14. DESCRIPTION OF AMENDMENT/MODIFICATION (Organized by UCF section headings, including solicitation/contract subject matter where feasible.)  
The Bidding Schedule, Specifications and Drawings for ALTER DEFENSE PRINTING FACILITY, LACKLAND AIR FORCE BASE, SAN ANTONIO, TEXAS, is amended as follows:

ALTER DEFENSE PRINTING SERVICE FACILITY  
KELLY/LACKLAND AFB  
DAC63-98-B-0032  
PROJECT NO. MBPB 99-3228  
SAN ANTONIO, TEXAS

AMENDMENT NO. 0002

**6** ELEVATION / PLAN DETAIL

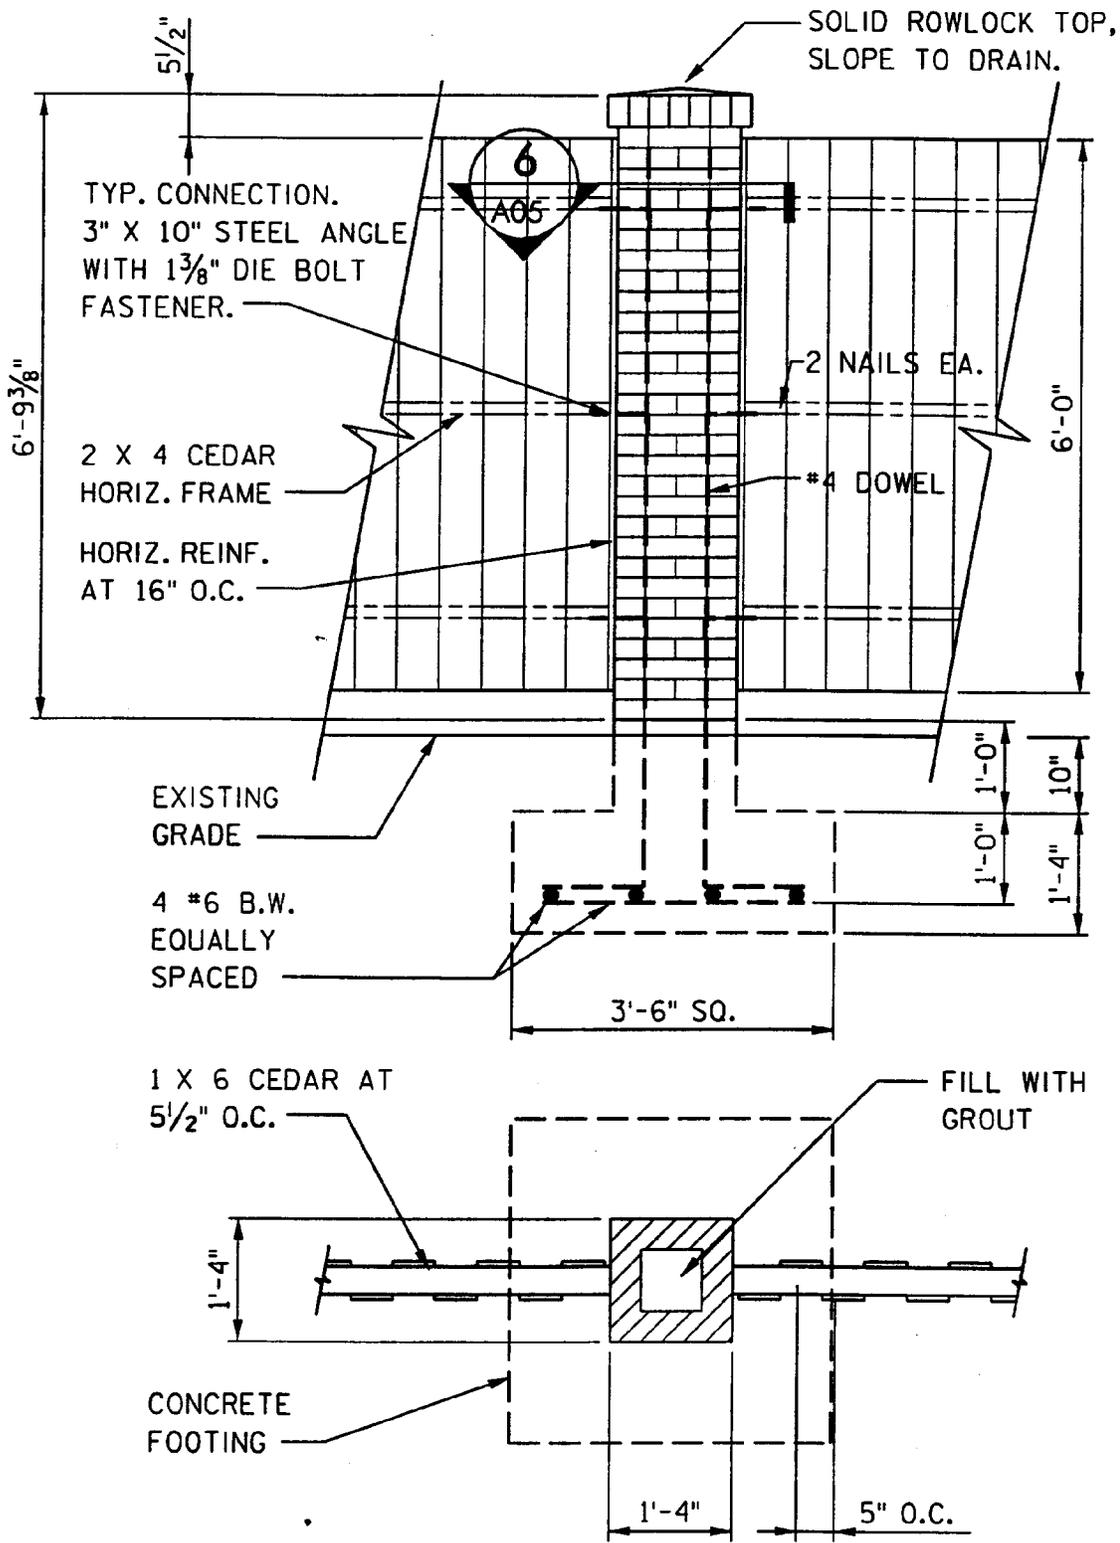
(3) Sequence No. 15, Sheet A05, Architectural Building Elevations

Add Screen Fence Elevation 6/A05 and Detail 7/A05. Refer to Civil Drawings for location. Brick and wood screening shall match Lackland AFB Standard. Add the following notes to the above detail:

- a. Horizontal Reinforcing: Provide ladder design for single wythe masonry, perpendicular rods spaced at 16" O.C. All wire diameter 0.1483 inch.
- b. Provide masonry mortar, color to match base standard, meeting requirements of ASTM C1142.
- c. Provide modular brick, ACME 6910 or equal.
- d. Lumber for fencing shall be No. 1 Cedar, stained with the Base Standard brown stain, Federal color 20059.
